CITY of ESCONDIDO

COUNCIL MEETING AGENDA

WEDNESDAY, SEPTEMBER 11, 2024

Final EIR Figure 3.9-3 with Modified Barrier Segment Identified

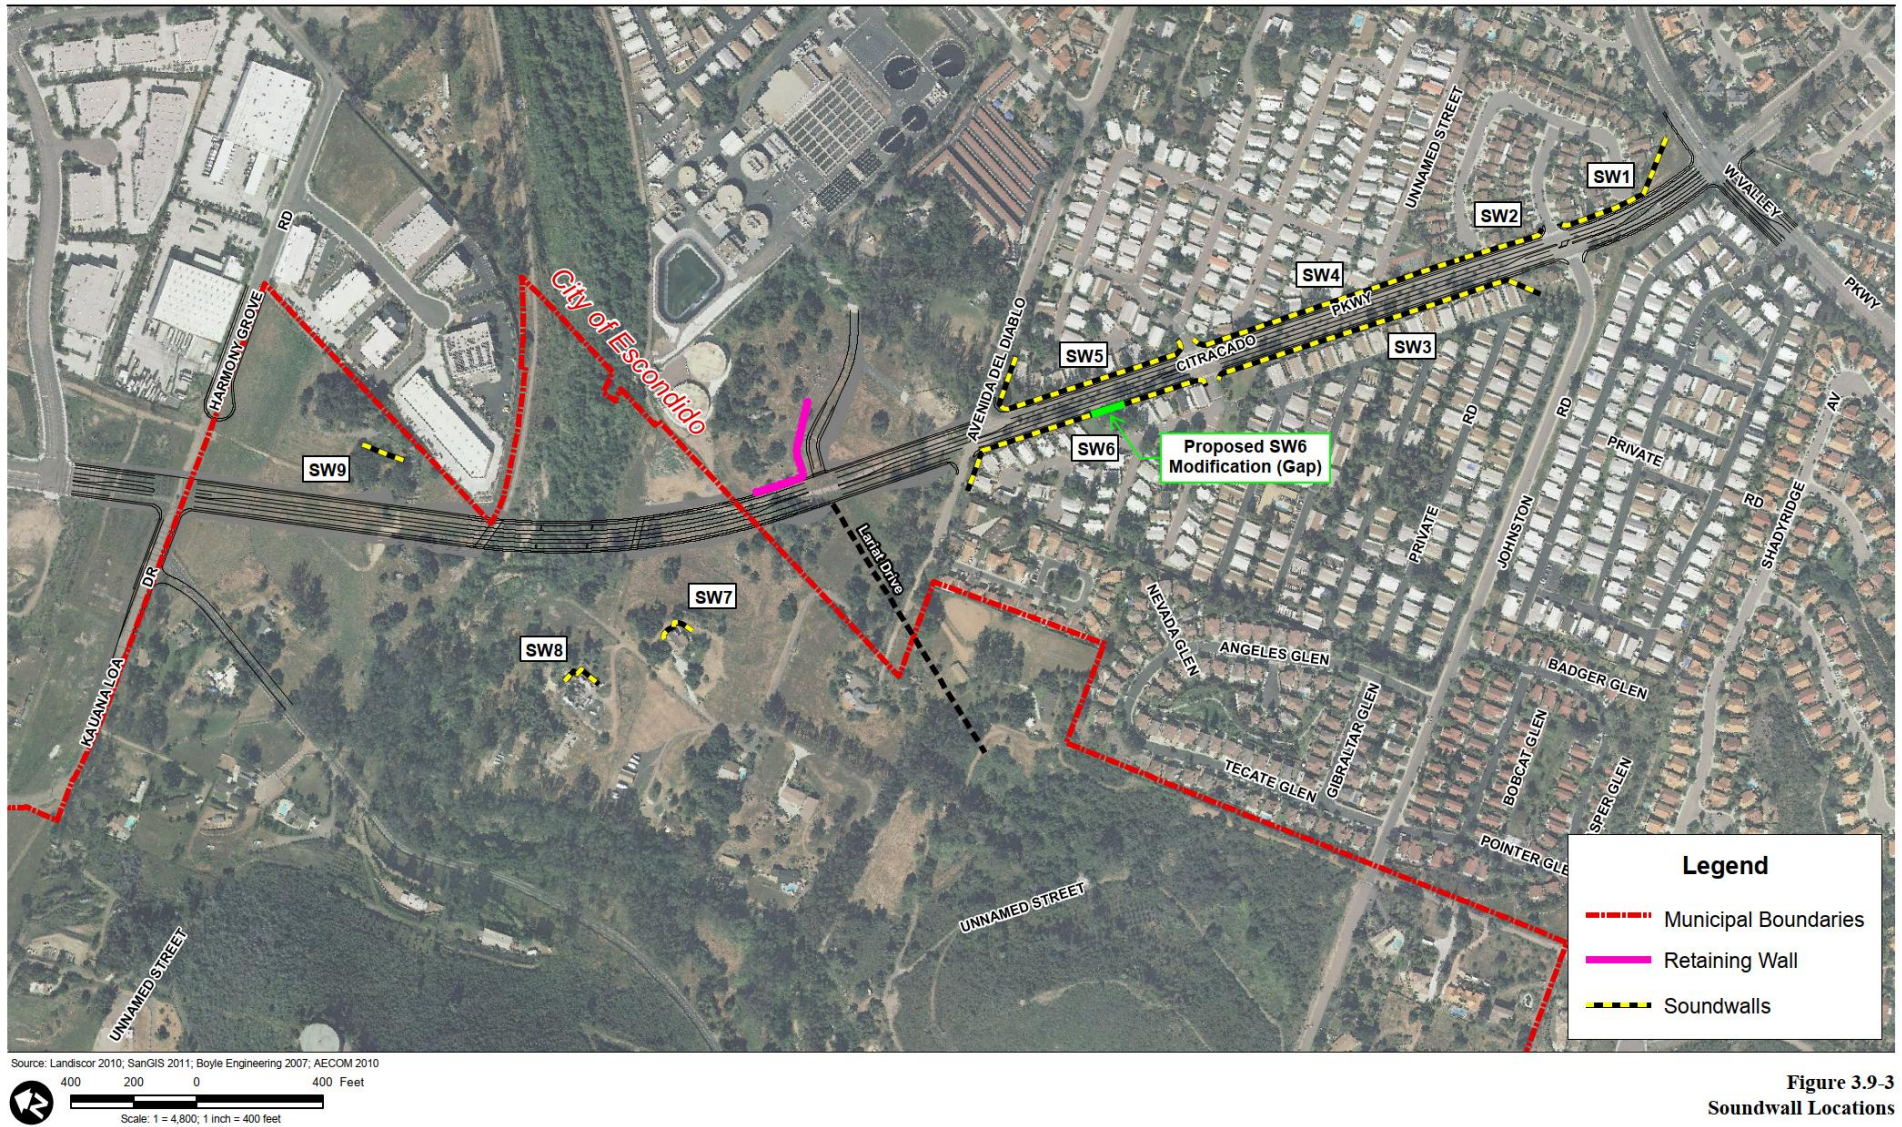
Addendum No. 3 covers a modification to the design of a segment of Sound Wall 6 (MMM-NOISE-1) due to constructability issues encountered along its alignment during construction. The proposed change would exclude an approximately 104-foot-long segment from the original alignment of Sound Wall 6, leaving this gap with no man-made noise control measures. This change would reduce the total length of Sound Wall 6 from 935 feet to a two-segment wall spanning a combined length of 831 feet. The installation for this segment of Sound Wall 6 is constrained by two factors: 1) a shallower water table than previously anticipated, and; 2) a large rock outcropping that occurs both above and below the ground surface. Both the shallow ground water and existing rock outcropping inhibits the ability to drill the required sound wall footings. The Addendum No. 3 Resolution and its associated Exhibits conclude no new noise or increased noise impacts would result beyond those identified in the FEIR and subsequent addendums (i.e., Addenda 1 and 2) with the removal of the 104-foot-long segment due to the existing rock outcropping.

Final EIR Figure 3.9-3, included as **Attachment A**, has been marked up by AECOM to identify the segment of SW6 where construction feasibility is inhibited. AECOM posits that the critical component of this mitigation measure is that the barrier would reduce traffic noise levels by a minimum of 3 dBA at these two receptors. As often used in early environmental analyses, the 8-foot-high wall was used to prove that the implementation of a barrier would adequately reduce noise levels. Whether the minimum 3 dBA reduction is achieved at higher or lower wall heights, or as in this case, with missing segments, is open to reassessment as performed by AECOM in this analysis.

3. Addendum No. 3 was prepared for the Project modification entailing elimination of an approximately 104-foot-long segment from the original alignment of Sound Wall 6, leaving a gap with no man-made noise control measures and thus reducing the total length of Sound Wall 6 from 935 feet to a two-segment wall spanning a combined length of 831 feet.
